Dear Chair Mandelman and Commissioners,

Thank you for the opportunity to substantiate and elaborate on the comments I made at the May 26th CAC meeting.

Slide 4 Potential Station Locations

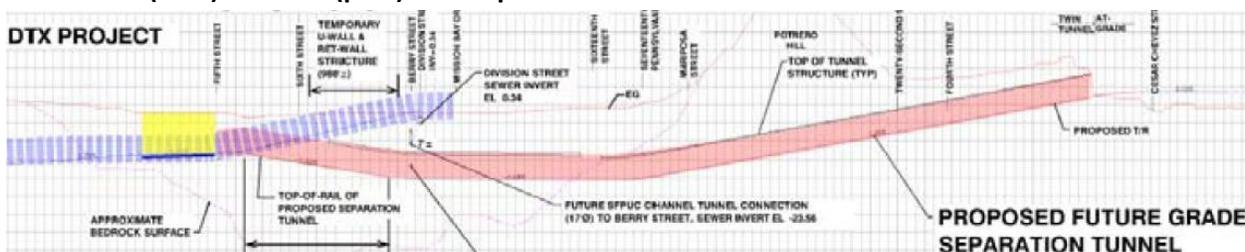
The first issue for your consideration is the “Potential Station Locations” on slide 4 because, as seen below, the tunnel profile on slide 3 would result in platforms sloping at 2% or more and the amount of excavation under the Central Segment (tunnel #1) and South Segment (tunnel #2) would result in massive surface impacts and prohibitive costs. The “Potential Station Locations” also do not take into account that non-stopping trains must be able to pass through the station(s) at 80 MPH resulting in an overall length of excavation of approximately 1,300 feet (300-foot throat + 700-foot platform(s) + 300-foot throat). This leaves two Potential Station Locations: a \$100M elevated station above Cesar Chavez (between western tunnel #2 and Highway 280) and/or a \$400M underground multimodal station under the North Segment (7th Street between 16th and Townsend) with seamless transfers to MUNI buses, the T-3rd and N-line extensions, the Central subway and the future 16th Street/UCSF BART station.

PAX Alternatives (slide 7)

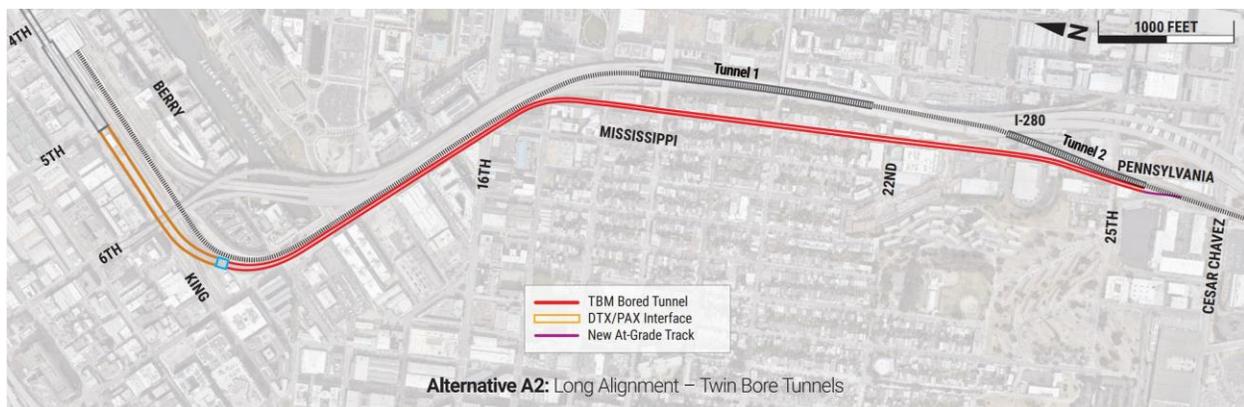
There are three issues with the discussion on this slide:

- 1) The primary discussion revolves around the relocation or modification of the 22nd Street station while ignoring the issue of sloping platforms as mentioned above.

- 2) There is no consideration of the nexus between the continued operation of the 4th & King railyard and the continued operation of the existing 22nd Street station, specifically that there will be no change to 22nd Street as long as Caltrain continues to provide service to the 4th & King railyard because passengers requiring access to the Cesar Chavez and/or 7th Street station(s) will board Transbay trains while passengers requiring access to the 22nd Street station will board trains terminating at 4th & King.

- 3) The third and final issue is that there is no consideration of phasing whereby Cesar Chavez could be constructed for initial Transbay operations and 7th Street could be constructed at a later date at which point Potrero Hill and the Central waterfront would be served by TWO Caltrain stations (Cesar Chavez to the South and 7th Street to the north) with 7th Street providing service to Mission Bay, including Oracle Park, the Chase Center and the future 4th & King railyard redevelopment.

Alternative B: Mid-length Alignment (slide 9)

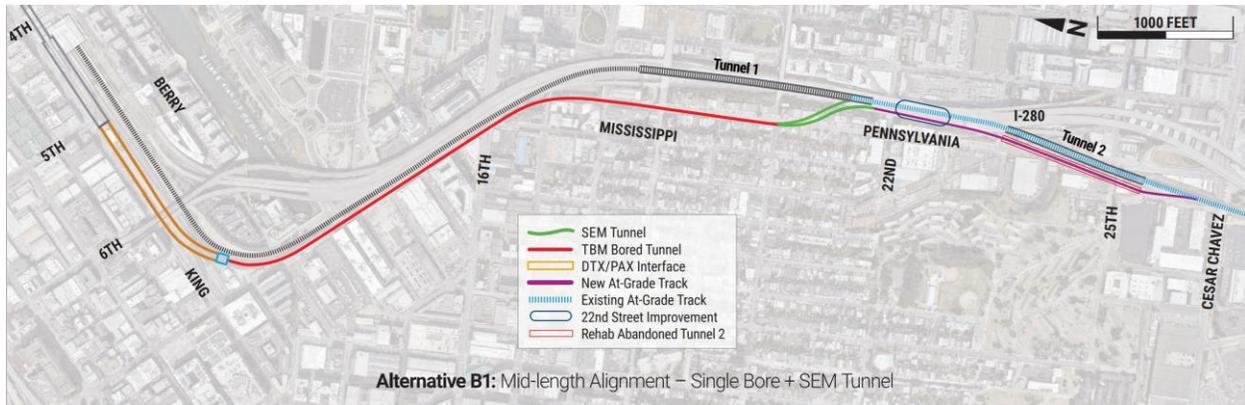
Alternative B1 (Single Bore Tunnel with SEM) has the same issues as Alternative A1 in the 7th Street/Berry area and is probably one of the worst alternatives in terms of constructability, surface impacts and costs.

Alternative B2 (Twin Bore Tunnel) is a superior solution because it has the potential to eliminate the SEM tunneling and continue north parallel to the 280 freeway (as envisioned by Southern Pacific) instead of making a sharp westward curve to align with Pennsylvania Avenue.

Alternative C Short Alignment

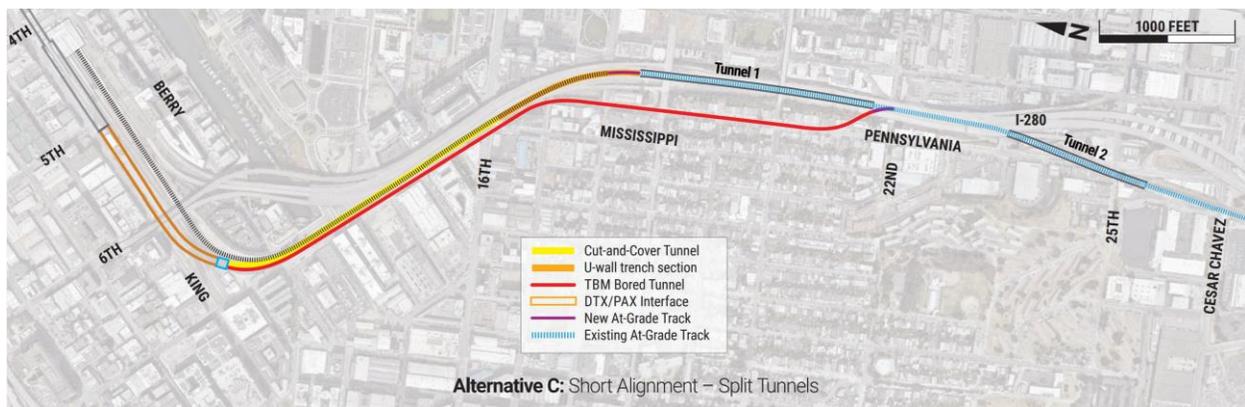
This is the worst of all alternatives because the cut & cover tunnel would interrupt Caltrain operations to 4th & King for a minimum of two years. Additionally, a cut & cover tunnel under the SSIP is not constructible and the distance between the bored tunnel and the existing tunnel #1 would result in unnecessarily long cross-passages whose construction is likely to compromise the structural integrity of tunnel #1.
